| *INFO-TECH* | Peugeot Sport | 208 R2 | 17-01 |

Object: SAFETY CAGE PROTECTIVE'S PADDINGS

253-68

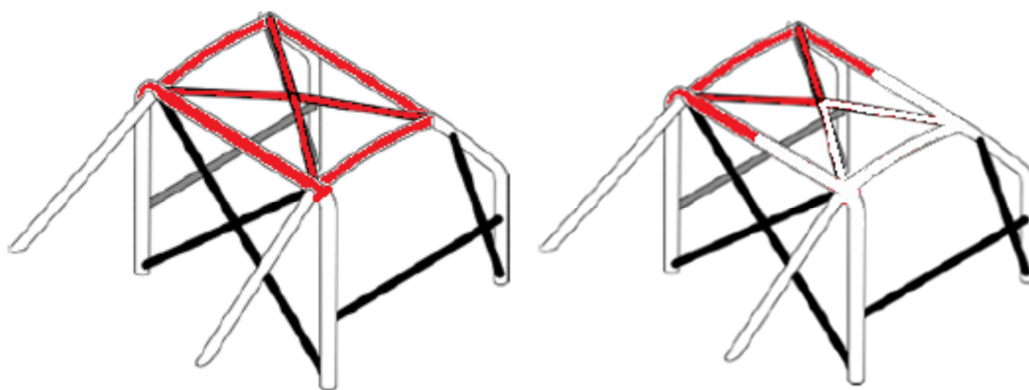
8.3.5 Protective padding
Where the occupants' bodies could come into contact with the safety cage, flame retardant padding must be provided for protection.

All tubes of the cage identified on Drawing 253-68 and all roof reinforcements must be fitted with paddings in compliance with FIA standard 8857-2001 type A (see Technical List n°23).

Each padding must be fixed in such a way that it is not moveable from the tube.

MOUNTING DIAGRAM – 208 R2 – TUBES'S SECTION CUTTING

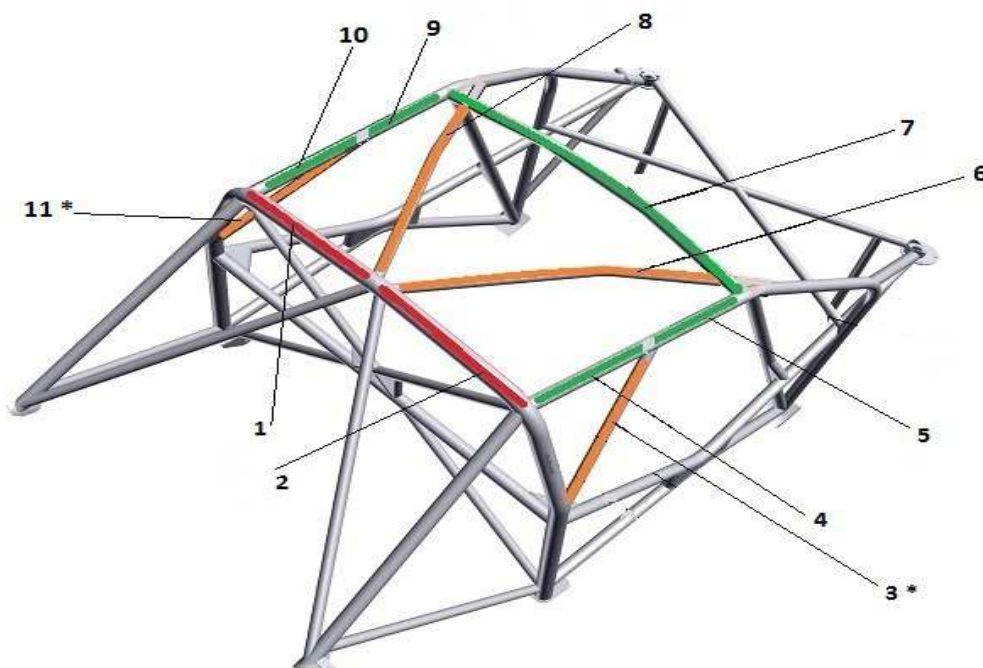
In order to comply with the FIA regulations concerning the safety of crews - Article 253-8.3.5 of Annex J - it is now compulsory in competitions organized by the FIA to set up protections where the occupant's bodies could come into contact with the safety cage.
